REMARKS

Application No. 10/811,791

Reply to Office Action dated April 14, 2006

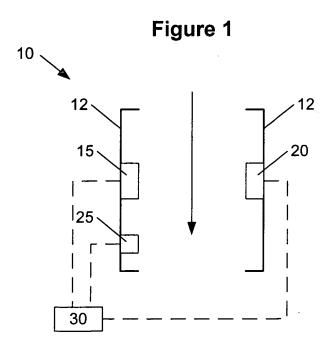
Figure 1 (reproduced below) stands objected due to reference to item "30" therein. As disclosed in the specification as originally filed, Figure 1 depicts an acoustic gas sensor 10 for measuring the hydrogen concentration of a gas (represented by the arrow) passing through housing 12. A transmitting transducer 15 and receiving transducer 20 are positioned in housing 12 a fixed distance apart and driven by electric signals. In addition, a temperature sensor 25 may be present to measure the temperature of the gas and eliminate the temperature dependence of the velocity of sound in the gas. (See, e.g., specification at page 5, lines 6-16.)

For purpose of clarity, Applicants have amended the specification at page 5, lines 6-16, to identify controller 30 for measuring the hydrogen concentration of the gas passing through the acoustic gas sensor, wherein in the controller is in communication with transponders 15 and 20, and with the temperature sensor 25 (as indicated by the dashed lines). Applicants

submit that this amendment is merely for purpose of clarity and does not constitute addition of new matter.

In view of the amendment to the specification, reference to item "30" in Figure 1 is proper and withdrawal of this objection is respectfully requested.
